Subject: Discontinuance of production for micro-switch MS-2H

2. Dimensions

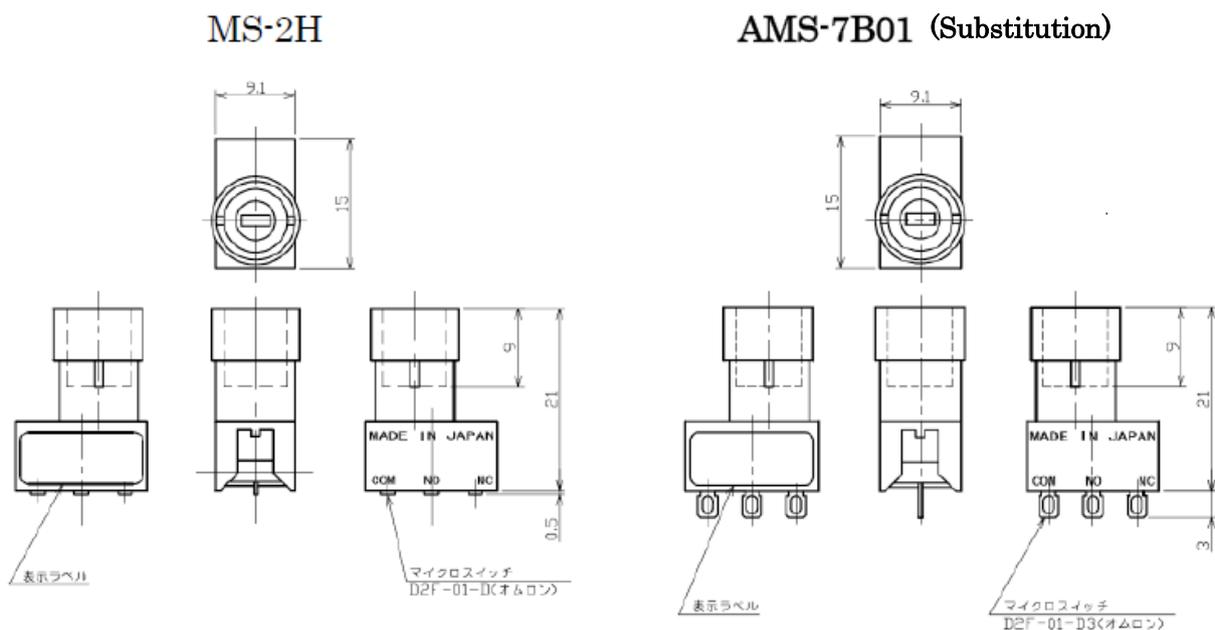
AMS-7B01 has a switch with longer terminals enabling easier soldering. There is no difference between MS-2H and AMS-7B01 in terms of the electrical characteristics and environmental resistance. The outward form and the installation are the same as those of MS-2H.
